Project	IEEE 802.16 Broadband Wireless Access Working Group http://ieee802.org/16			
Title	Encoding of the GPS time in the LBS-ADV message			
Date Submitted	2008-10-29			
Source(s)	Erik Colban, Lei Wang, Kenneth Stanwood, Yair Bourlas NextWave Wireless*	Voice: E-mail: ecolban@nextwave.com; lwang@nextwave.com; kstanwood@nextwave.com ybourlas@nextwave.com

* <http: affiliationfaq.htm<br="" faqs="" standards.ieee.org="">l></http:>		
Re:	802.16 Rev2 Sponsor Ballot			
Abstract	This contribution proposes a correction and improvement of the encoding of the GPS time in the LBS-ADV message.			
Purpose	To be discussed and adopted by 802.16 Rev2.			
Notice	This document does not represent the agreed views of the IEEE 802.16 Working Group or any of its subgroups. It represents only the views of the participants listed in the "Source(s)" field above. It is offered as a basis for discussion. It is not binding on the contributor(s), who reserve(s) the right to add, amend or withdraw material contained herein.			
Release	The contributor grants a free, irrevocable license to the IEEE to incorporate material contained in this contribution, and any modifications thereof, in the creation of an IEEE St

Figure 3: Adjusting the clock at the MS

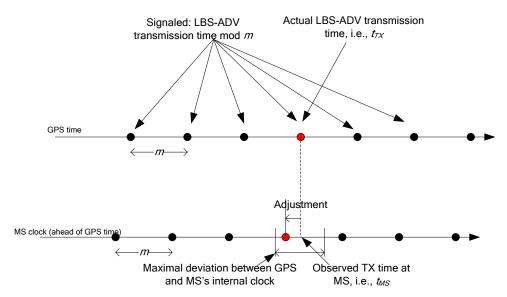
Assume that the frame duration is 5 ms. The MS' internal clock shows 11:59:59 PM AOE, on September 11th, 2008, when it receives the LBS-ADV message. This time translates to GPS time 1221220799 (Ref. http://www.mapshots.com/tools/gps_time.asp). The LBS-ADV message is transmitted in frame 12345678 and signals the pair (1690652, -150). When the LBS-ADV message is transmitted, the GPS time is (1690652 + 12345678 + $N \times 2^{22}$) × 5ms - 150 × 2ns + ε , where ε is bounded by the signaled accuracy. Assuming that the MS' internal clock is accurate within $2^{22} \times 5$ ms / $2 \approx 10485$ seconds, the number N is calculated as follows:

$$N = \left[\frac{1221220799 \text{ s} - (1690652 + 12345678) \times 5 \text{ ms}}{2^{22} \times 5 \text{ ms}} + 0.5 \right] = 58229$$

The GPS time at the BS when the LBS-ADV message was transmitted was $1221220819.729999700 + \epsilon$. (The MS' internal clock is almost 21 seconds too slow.)
